ADDENDUM # 2
Grass Valley School District
District Support Services Building
Gilmore Way, Grass Valley CA

DISTRICT SUPPORT SERVICES BLDG for GRASS VALLEY SCHOOL DISTRICT
 GILMORE WAY, GRASS VALLEY, APN29-030-02

E0.1

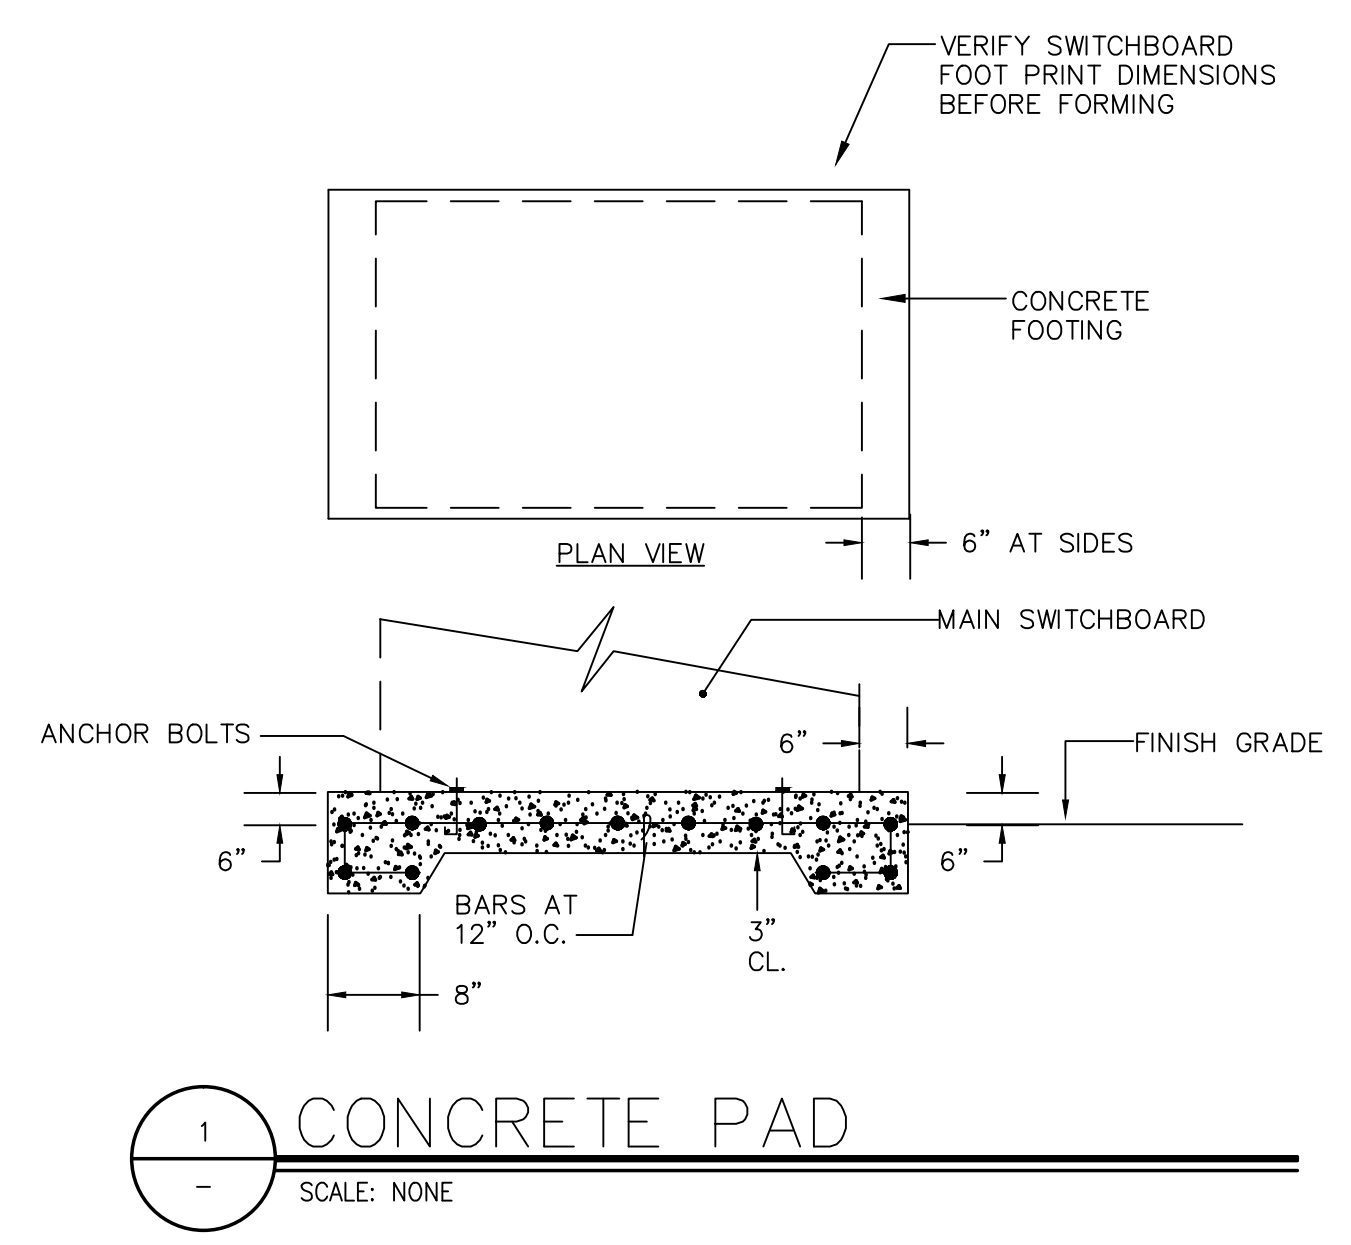
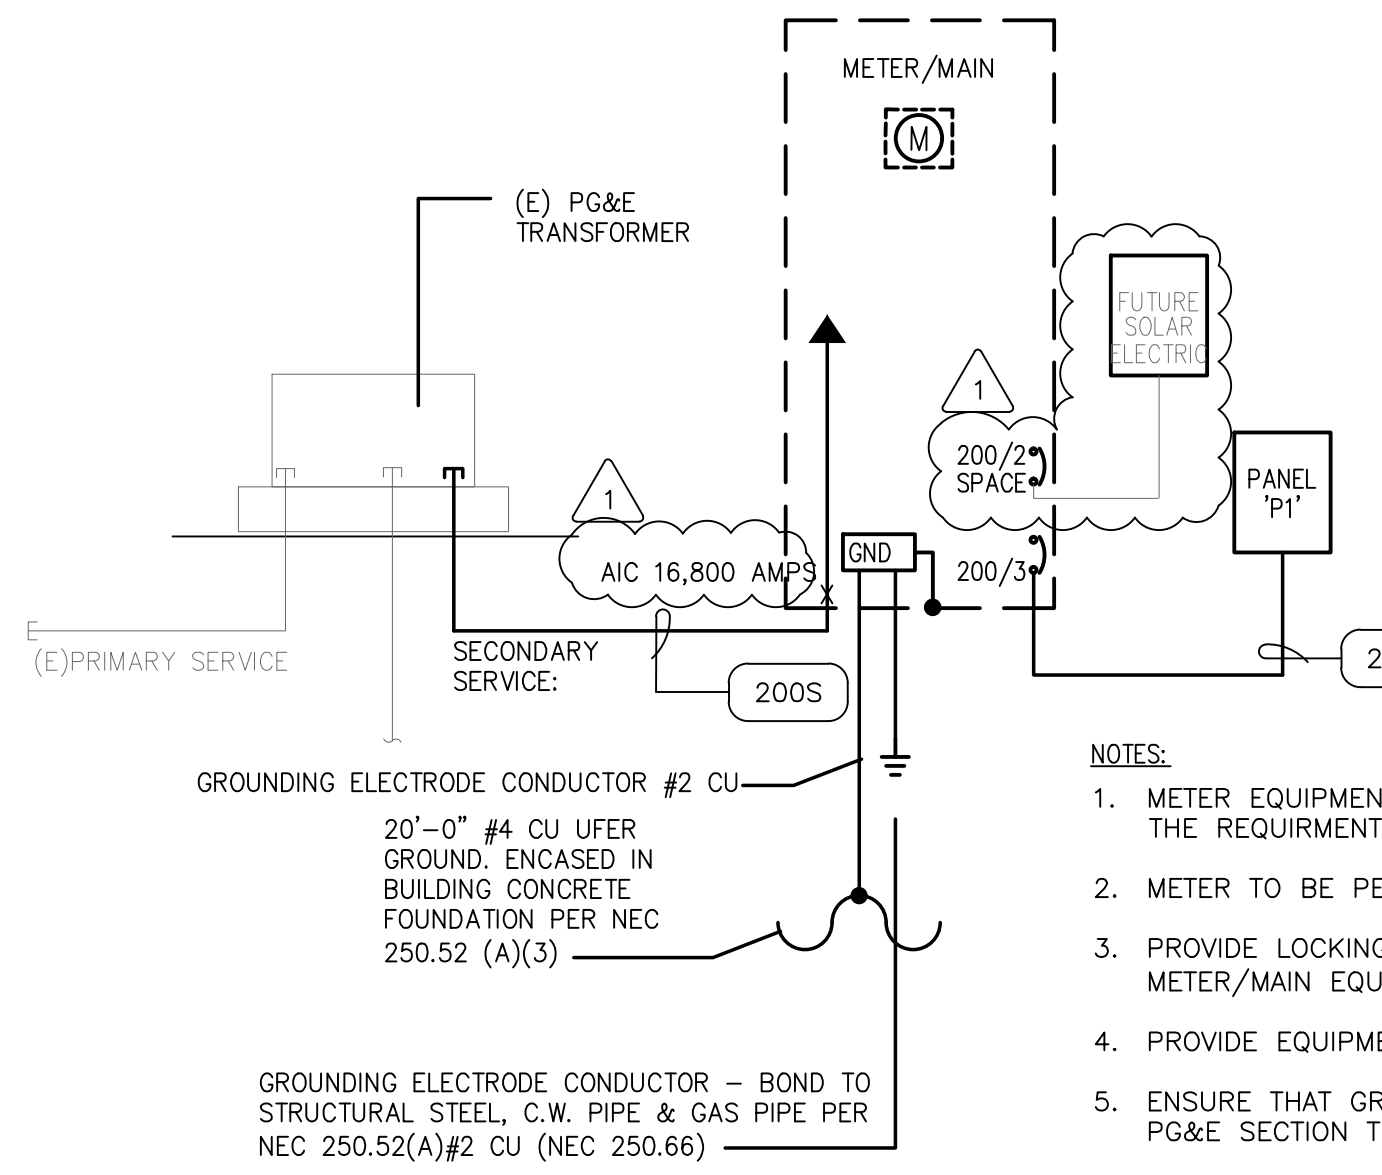
1. Electrical conduit and related connections have been added at to allow for future photovoltaic infrastructure, see sheet E0.1, grid coordinates F7, and sheet E3.1, grid coordinates H5.
2. Two occupant load signs have been added, one at each exterior door.
3. Special Inspection will be required to test the compaction of the fill below the relocated shipping container.
4. Additional emergency lighting fixtures have been added, see sheet E2.1.
5. Additional electrical receptacles have been added, see sheet E0.2 and E3.1.
6. A request for a Bid Alternate has been added to the scope, see attached "Alternates Form" and revised "Required Bidding Forms" list.
7. Reference is made to sheet C3.2, detail A90A, upper right corner. Contractor shall furnish and install at each of the two driveway entrances to the parking lot the
